Date: 20/12/2022
Our ref: 2022/4951/PRE
Contact: Kate Henry
Direct line: 020 7974 3794
Email: Kate.Henry@camden.gov.uk

Re: 19-37 Highgate Road, London, NW5 1JY - Variation of approved scheme reference 2013/5947/P, dated 18/06/2014 (as amended) [for: Demolition of existing buildings and redevelopment to provide: a new Centre for Independent Living at Greenwood Place; and mixed-use development at Highgate Road comprising residential units, including supported affordable housing units, and social enterprise space; highway improvements; plant, landscaping; servicing; disabled car parking etc.]. CHANGES PROPOSED: Elevational changes (omission of winter gardens); Crittal-style windows; simplified brick detailing; red bricks

Figure 6 – NO₂ concentrations – 1st Floor

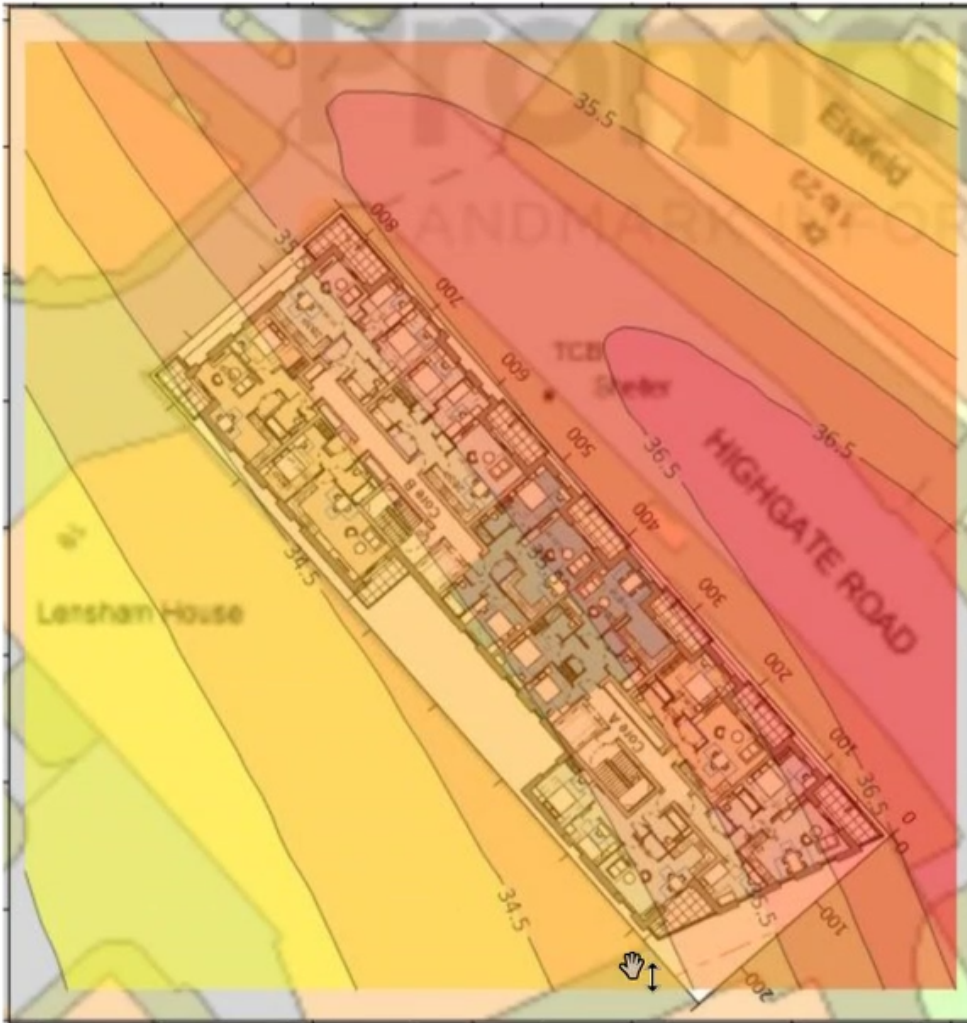
The results in the AQA have been modelled for the opening year of 2023. It is noted that at the first floor the NO_2 levels seem to be acceptable in this model but we do not accept future projections.

For any units which indicate annual levels of NO₂ over 38µg/m³ officers would like to see MVHR with air inlets from as close to roof level as possible and away from the busy road. We would not generally expect wintergardens unless the pollution levels are over 40-42µg/m³, which is not the case.

Therefore from the LAEI 2019 mapping it is anticipated that for the balconies at first floor and above wintergardens would not be required. However, to confirm this and to provide detail for the location of required MVHR we would expect the modelling in the AQA to be presented using the most up to date air quality monitoring data (N.B. 2019 - as the results for 2020/21 will be affected by the Covid-19 lockdowns).
